2009 Corvette Z06 and ZR1: GM TechLink Article: Oil System Changes - LS7 and LS9

Changes have been made to the dry-sump engine oil system used in the 2009 Corvette

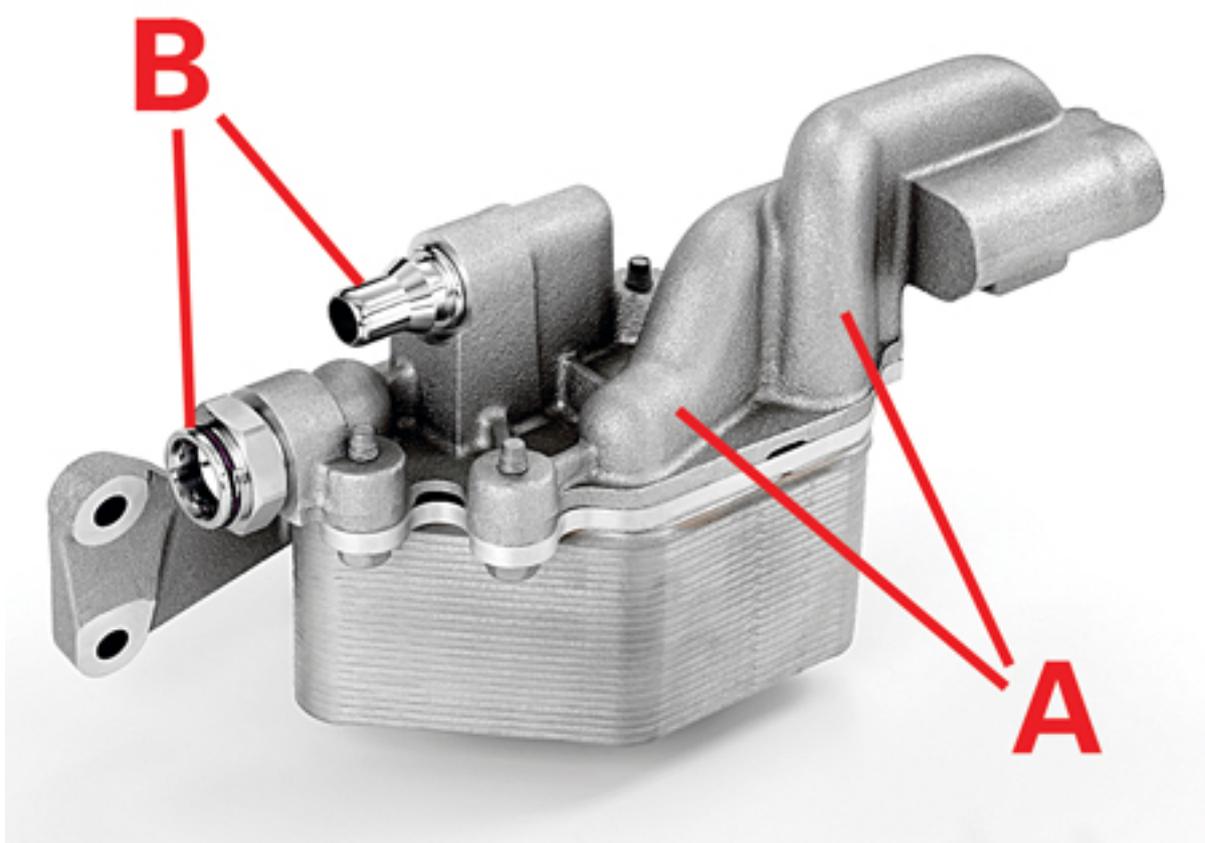
The dry sump system uses a dual gerotor oil pump, one rotor for scavenge and one rotor for supply (fig. 2) . The pump used on the LS9 produces greater volume and higher system oil pressure to provide adequate oil delivery under all conditions.

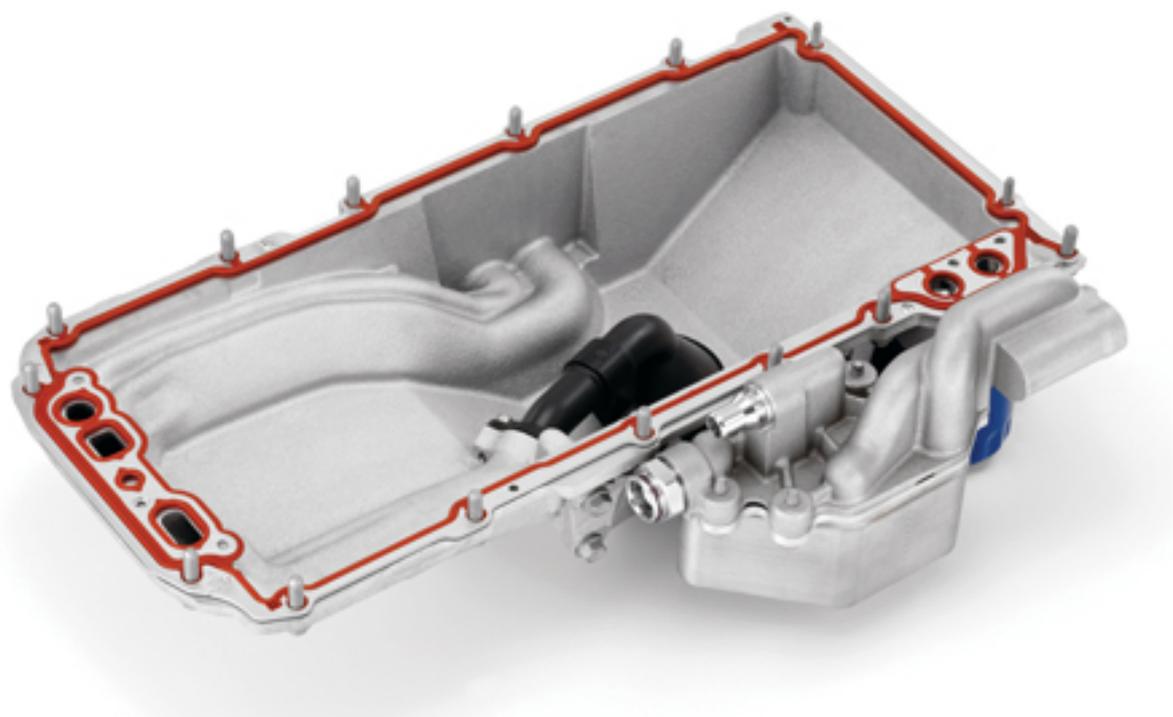
The LS9 uses eight oil squirters, one per cylinder, for additional lubrication of the pistons and cylinder walls (fig. 3) .

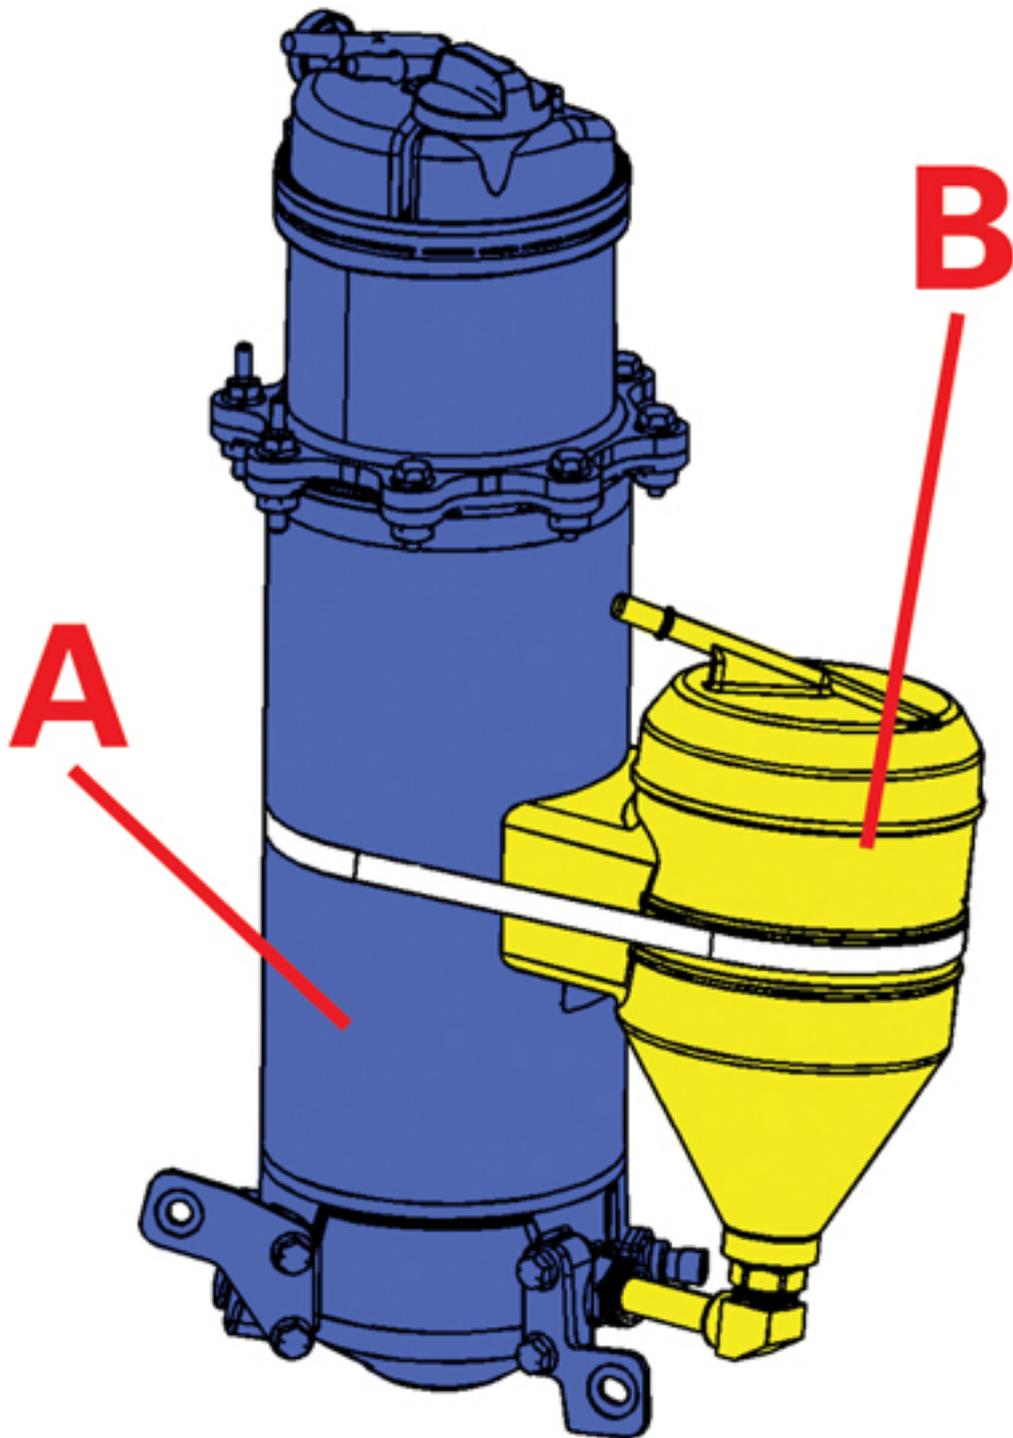
routed from the pan to an external engine oil cooler located in front of the coolant radiator. The 2009 LS9 uses the same pan with a different design oil cooler that is mounted on the left side of oil pan (fig. 5) .

A Oil passages

B Coolant fittings
